6522B County Permit Review Worksheet

IMPROVEMENT PERMIT for a RESIDENTIAL ON-SITE WASTEWATER TREATMENT & DISPOSAL SYSTEM

SOIL/SITE EVALUATION
for ON-SITE WASTEWATER SYSTEM

APPLICATION FOR APPROVAL TO USE AN EXISTING ON-SITE WASTEWATER TREATMENT & DISPOSAL SYSTEM
MECKLENBURG COUNTY - GROUNDWATER & WASTEWATER SERVICES
700 N. Tryon St., Suite 211 Charlotte, NC 28202
Phone: (704) 336-5103 Fax: (704) 336-6894

PROPOSED PLOT PLAN

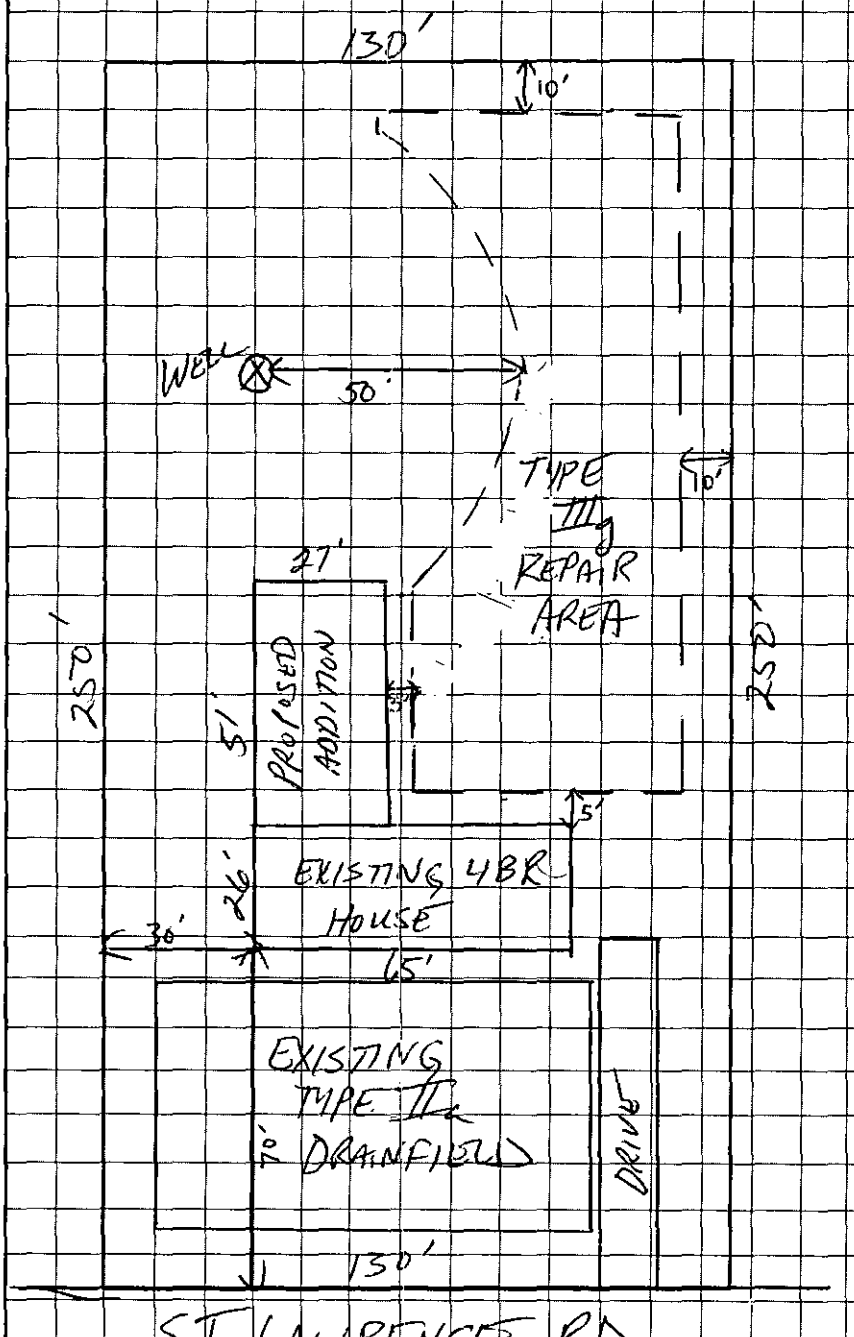
- 1" = 40'
- PLOT PLAN MODIFIED TO ACCOMODATE 27'x51' ADDITION
- ADDITION WILL NOT CHANGE NUMBER OF BEDROOMS ON EXISTING HOUSE
- INITIAL SYSTEM - TYPE II
- REPAIR SYSTEM TYPE III GRAVITY 25% REDUCTION
- MAINTAIN SETBACKS (ADDITION)
  - >5' FROM PROPOSED REPAIR
  - >25' FROM EXISTING WELL
- REPAIR AREA MUST REMAIN >50' FROM EXISTING WELL >10' FROM PROPERTY LINES

Comments:
MODIFIED PLOT PLAN TO RELOCATE REPAIR AREA FOR 4 BR RESIDENCE. AREA FOR PROPOSED ADDITION MEETS REQUIRED SETBACKS FROM EXISTING SYSTEM, REPAIR AREA, AND EXISTING WELL
